Subject: Technical Evaluation of Assessments of the Potential for PCE in Groundwater Associated with the MKC site to Impact Unit Well #8

**TECHNICAL EVALUATION OF ASSESSMENT OF THE POTENTIAL FOR PCE IN
GROUNDWATER ASSOCIATED WITH THE MADISON-KIPP CORPORATION
SITE TO IMPACT UNIT WELL #8**

Prepared for:

City of Madison Water Utility

Figure 1. Hydraulic head profiles calculated using the MKC site Westbay multilevel system data (Arcadis, 2013). Lithostratigraphic data is approximated from figures provided in Arcadis (2013).

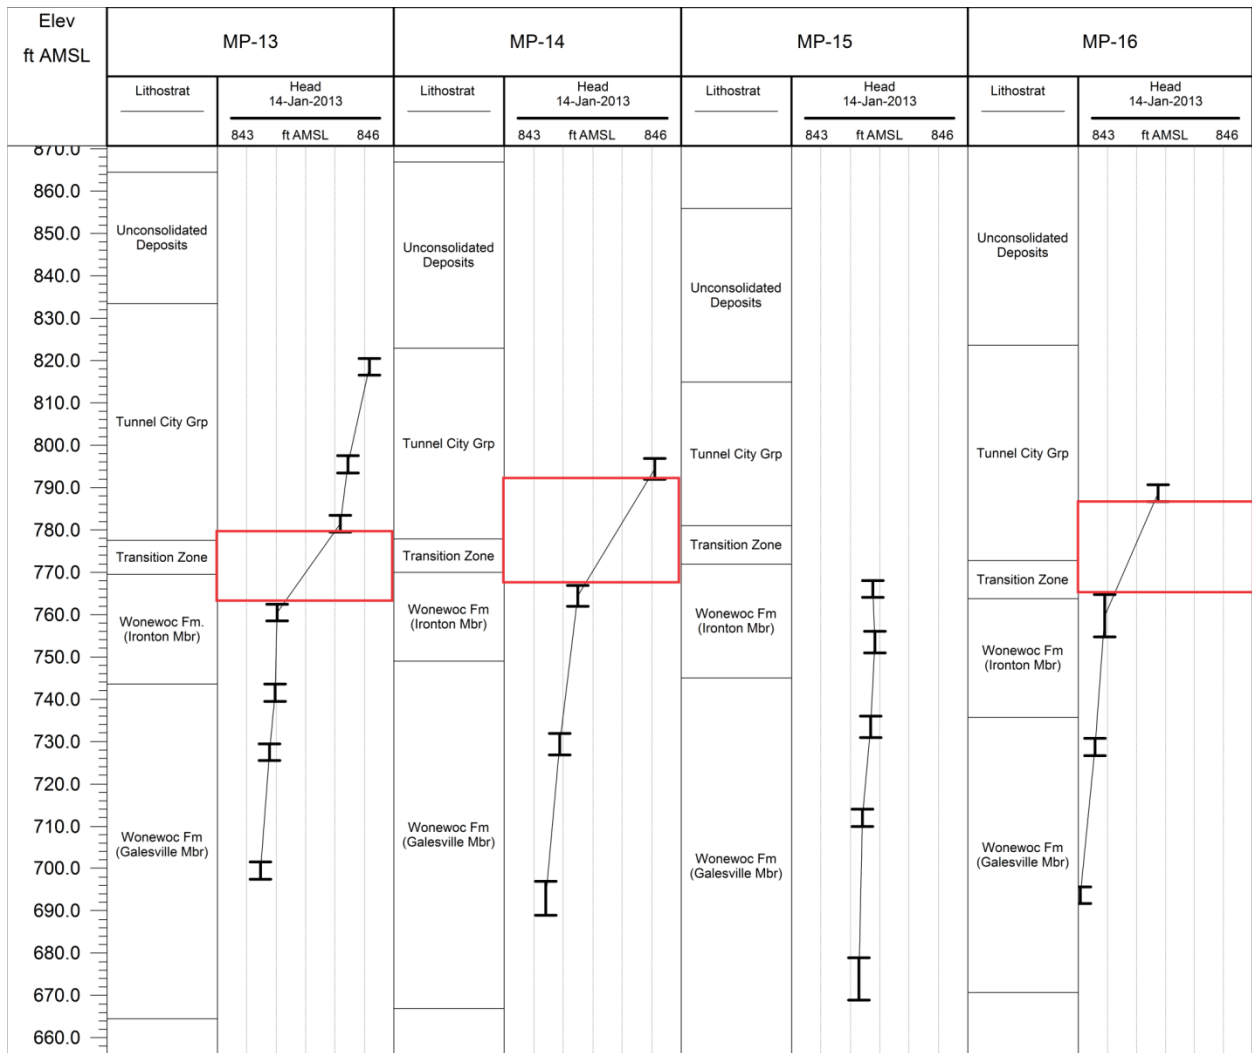
Four Westbay MLS installed at the MKC site provide vertical head profile data; however, hydraulic head profiles are not presented in the site documentation reviewed here. Therefore, head data from the four MLS (Arcadis, 2013, table 4-1) were plotted in order to provide an example of how such data can be utilized and evaluate the existing site hydrogeologic unit conceptual model (Figure 1). The MP-13 head profile shows a sharp decrease in head of 1.07 ft between 780 and 763 ft AMSL. A similar, but less resolved, change in head appears in the MP-14 and MP-16 profiles. This distinct head change roughly coincides with the upper most portion of the Wonewoc Formation which has been described as the Iron-ton transition zone at the site (Arcadis, 2013). The MP-15 MLS does not include monitoring intervals in the Tunnel City Group and therefore does not include the head change. The distinct change in head observed at three locations bracketing the site to the north, west, and east indicates a contrast in hydraulic conductivity that potentially extends across the entire area of the PCE plume. The presence of a laterally extensive hydraulic conductivity contrast within the upper Paleozoic aquifer (Tunnel City Group, Wonewoc Formation, and portion of Eau Claire Formation above the aquitard) would not be consistent with the conceptual model where the upper Paleozoic aquifer functions as a single hydrogeologic unit.

The hydraulic head profiles (Figure 1) also provide additional insight regarding the vertical hydraulic gradients at the site. Arcadis (2013) notes that the vertical gradients are predominantly downward and vary in magnitude between 0.012 and 0.033 for the conventional wells and 0.013 and 0.019 for the Westbay MLS. However, calculation of the vertical gradient associated with the 1.07 ft of head lost across the transition zone in the MP-13 MLS yields a vertical gradient of 0.063. This vertical gradient is calculated by dividing the head loss (1.07 ft) by the distance between the bottom of the upper monitoring interval and the top of the lower monitoring interval (17 ft). The calculation assumes the contrast in hydraulic conductivity responsible for the head loss is 17 ft thick and located between the two monitoring intervals. Research at a nearby field site (Meyer et al., 2008; Meyer et al., 2014) suggest the hydraulic

conductivity contrasts associated with this head loss is substantially thinner than 17 ft and therefore the vertical gradient of 0.063 is likely underestimated.

- Utilizing the site specific data to refine the hydrogeologic unit conceptual model for the site.
- Re-evaluating site specific data within the context of the refined hydrogeologic unit conceptual model
 - Redefine potentiometric surfaces
 - Re-calculate horizontal and vertical components of gradient
 - Reassess range and average values of hydraulic conductivity
 - Provide statistical estimates of other important flow and contaminant transport parameters such as fracture spacing and aperture, matrix porosity, and fraction of organic carbon.
